Certificate of Appropriateness

Property2204 E. IVANHOE PL.North Point South HDDescription of workRepair and rebuild chimney per attached description and conditions below.Date issued9/22/2018PTS ID114626 COA: chimney repair

Chimney prior to collapse, c. 2011. Flue caps must remain visible after repairs and be identical to existing profile. Utilizing an 85' aerial lift, dismantle upper portion of chimney and rebuild.

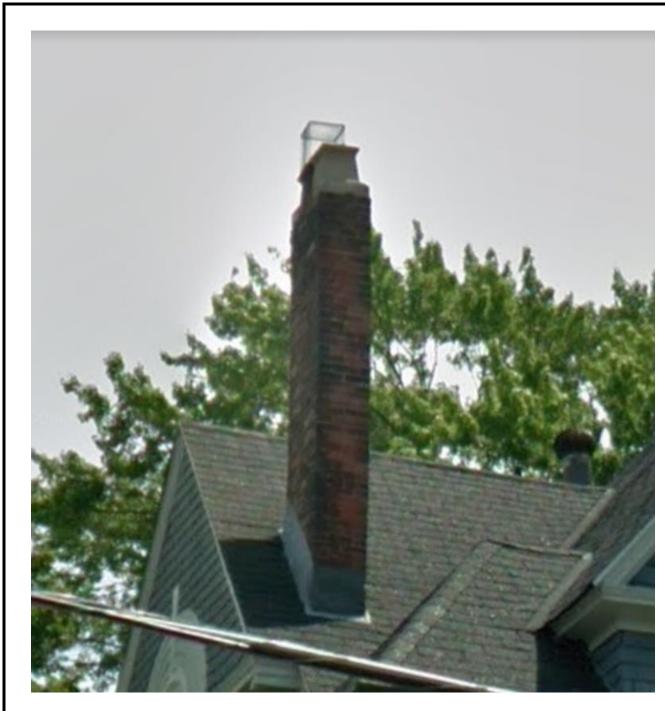
100% grinding of mortar joints 3/r deep and repoint with new color matching mortar.

Chimney to be rebuilt matching original design and contour.

Mortar to be used will be 6 parts sand, 1 part Portland and 1 part Lime.

Install chimney bonnet on top flues.

Clay tile flues to be replaced as needed.

New mortar must match the original mortar in terms of color, texture, grain size, joint width, and joint finish/profile. The compressive strength of the repointing mortar shall be equal or less than the compressive strength of the original mortar and surrounding brick or stone. The replacement mortar shall contain approximately the same ingredient proportions of the original mortar. Mortar that is too hard is subject to premature failure and could damage the masonry. No over-cutting of the joints is permitted. Remove decomposed mortar back into the wall 2.5 times the height of the joint before repointing. New brick must match as closely as possible the color texture, size, and finish of the original brick.

Chimney bonnet must be copper/copper alloy or be a painted/powder-coated metal. No bare white metal finish is permitted.
